SUBJECT: Sand Hill Estates #4 Major Plat – Deferral Request – Recommendation to Hearing Examiner

Re: Sand Hill Estates #4 Major Plat – Planning Commission Recommendations on Deviations/Deferrals

**From:** Scott McArthur <scott@mcArthur-eng.com>  
**Sent:** Wednesday, March 2, 2022 7:56 PM  
**To:** Anne Henning  
**Cc:** Angel Garza  
**Subject:** Sand Hill IV - Phasing or Modifications

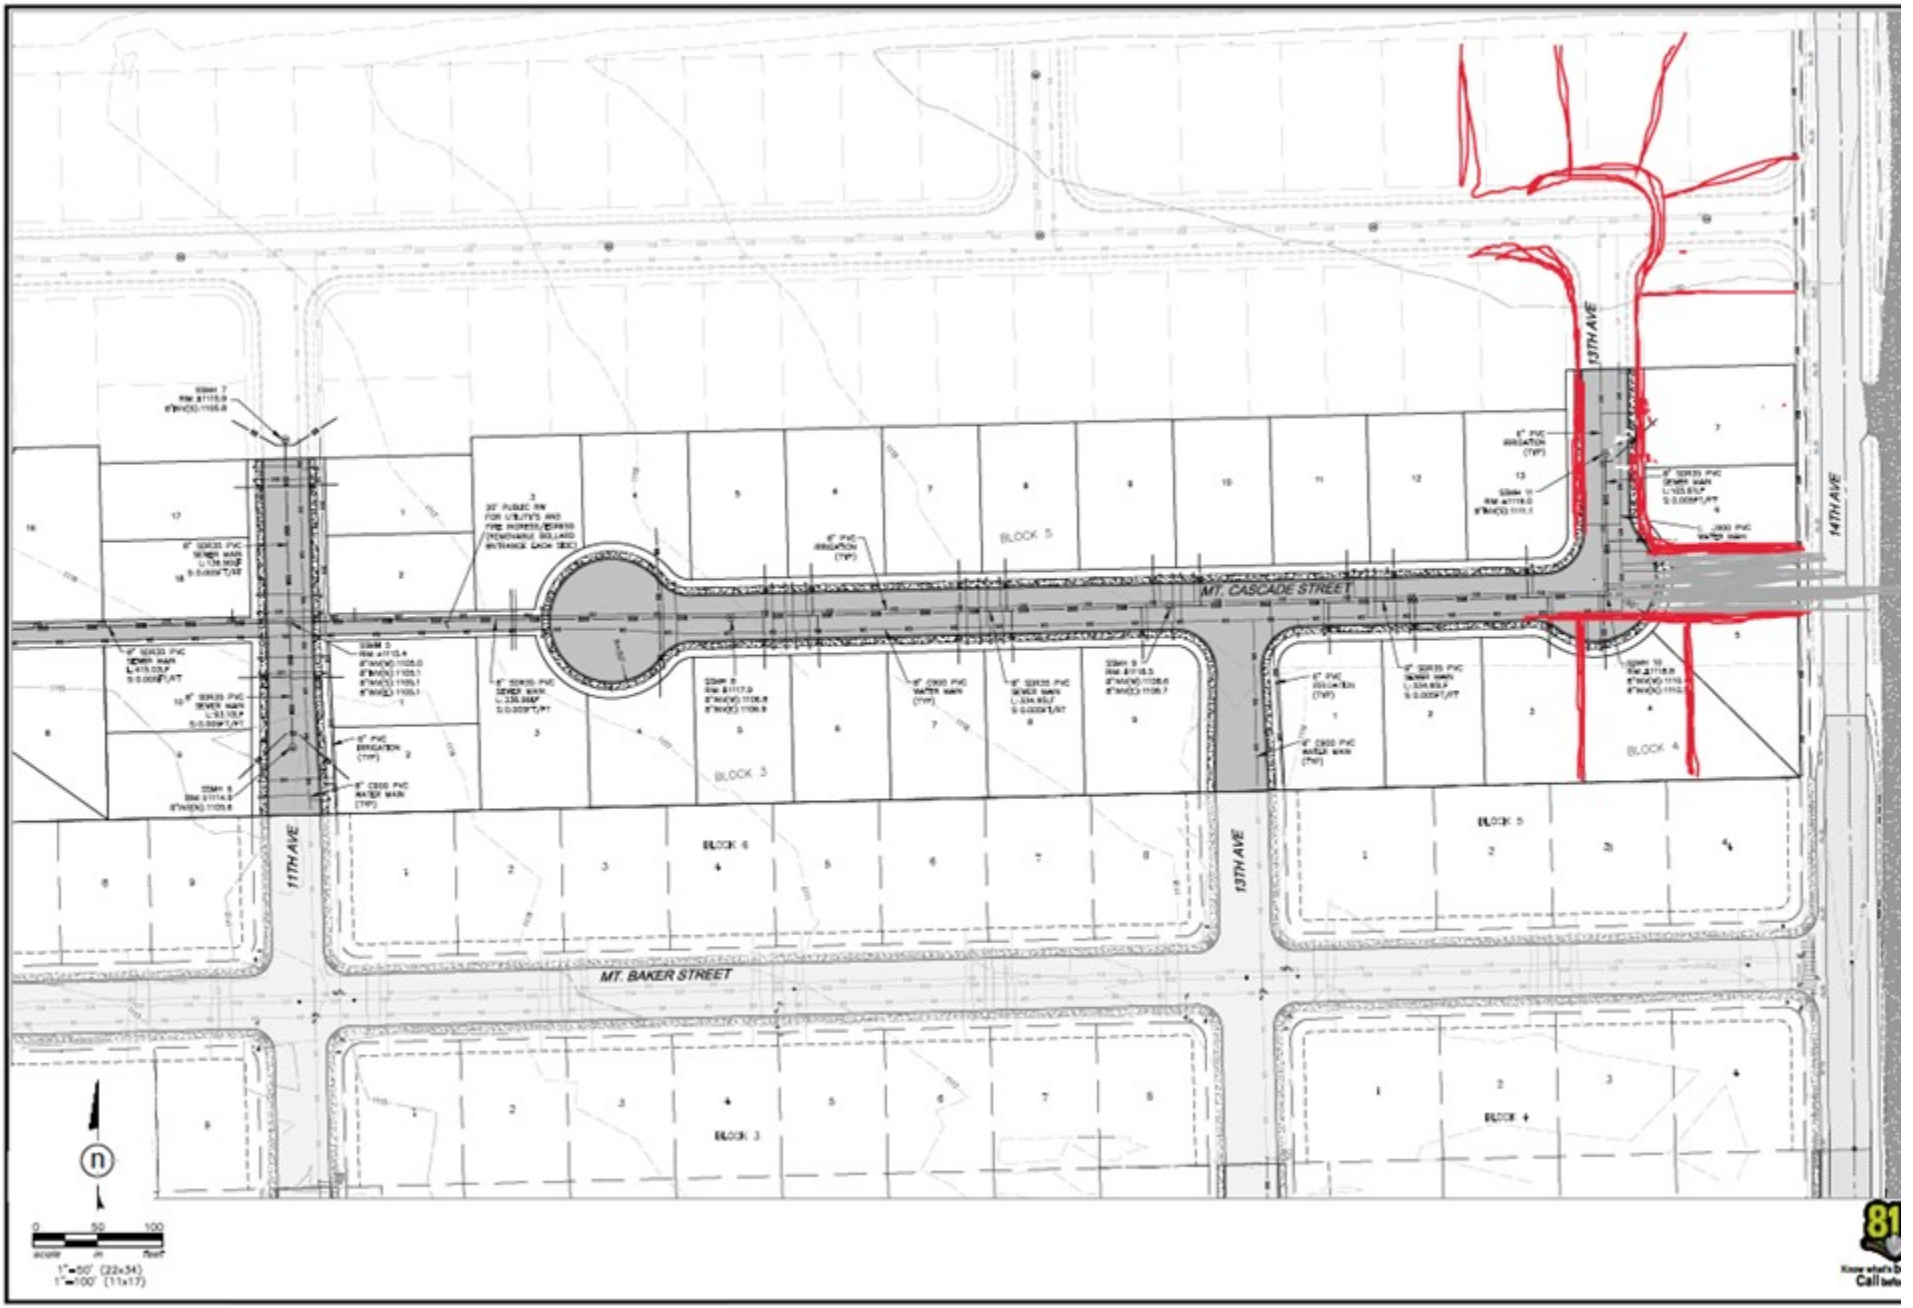
- a. Do we break this in to a Phase IV-A and a Phase IV-B, and then just limit the building permits for Phase IV-B to 20 Homes until a second access is provided to 14<sup>th</sup> Avenue
- b. As discussed, we could make this 20-Lot development until access is provided a condition of approval, or we could prepare a formal/legal document to such, and note the verbiage on the Plat in some manner.

I think I like the design with the direct connection from Mt. Cascade to 14th. But that's just me looking at it on my phone while riding a bus. At this late date, I don't see how we can move forward with any significant changes to the layout. I can't count on people to be available to review it in one day. And the public notification was done based on a particular layout. How serious a problem is it to just move forward with the A portion for now, then you can figure out the east side and submit it as it's own plat, which can get a full review?

So today is the day I need to finish my staff report. I'm just going to have to go with the "A" portion as the plat for this review. We can discuss the layout options for the rest of it next week, so you can get going on applying if you now feel that you will be ready to build the eastern half soon.
